Service Bulletin

Bulletin No. 2007-63
CMD 2007-03

QSD 2.0 Sterndrive Power Steering Cooler Interference

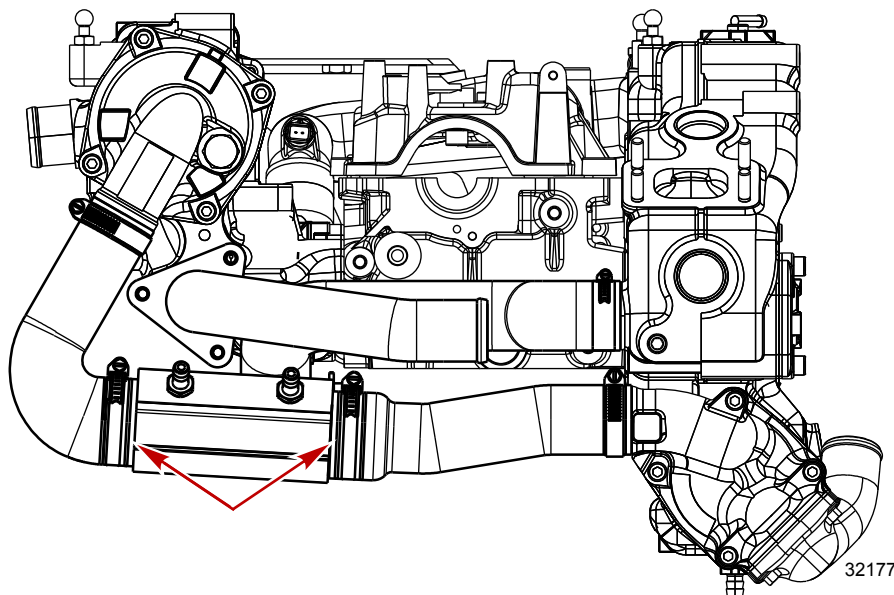
QSD 2.0 sterndrive models within the serial number range may have an interference between the power steering cooler fittings and the clevis of the steering ram when the drive is turned hard to the right.

NOTE: *Steering clevis is in its leftmost position looking at the rear of the vessel.*

Inspect for interference of the steering control valve clevis and the power steering cooler fitting when the drive is turned full starboard.

If there is interference, modify the cooler orientation as follows:

Hose clamps

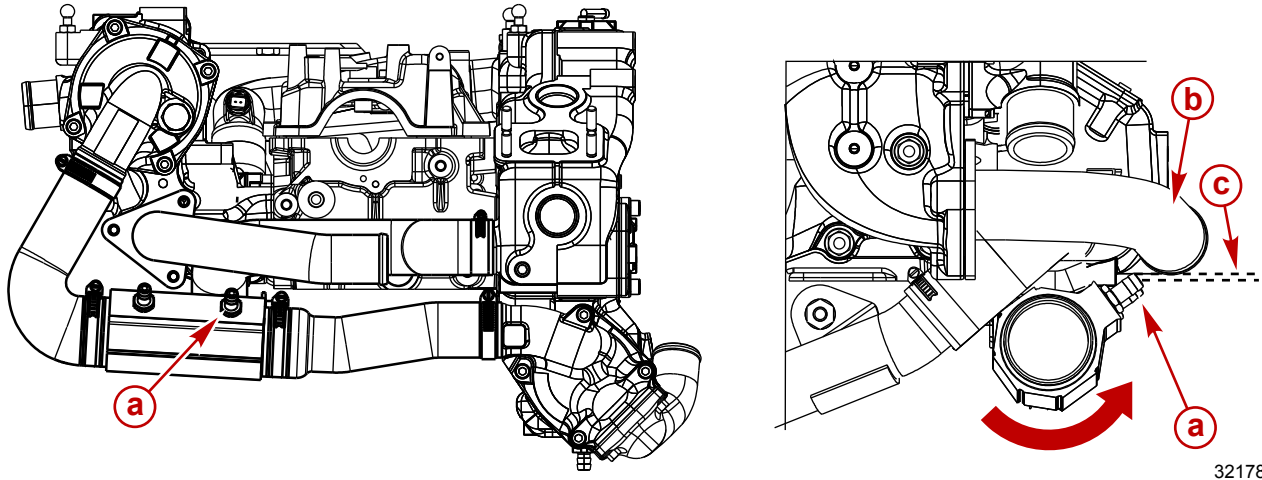
2. Close the seacock, if equipped, or disconnect and plug the seawater inlet hose.
3. Drain the seawater system.
4. Remove the air cleaner assembly, if necessary, for access.
5. Loosen the hose clamps on both ends of the power steering cooler.

- Rotate the power steering cooler until there is clearance between the referenced fitting and the under side of the air crossover tube.

32183

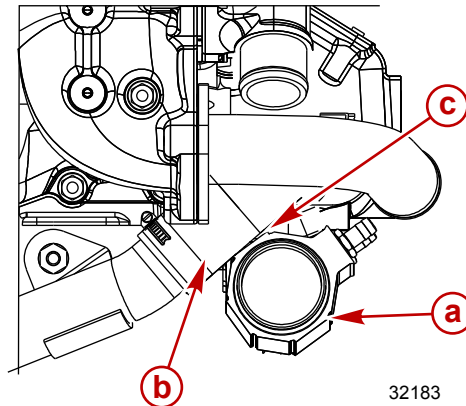
- Check for interference between the back of the power steering cooler and the engine coolant hose. Adjust if necessary.

- a** - Power steering cooler
- b** - Engine coolant hose
- c** - Possible interference
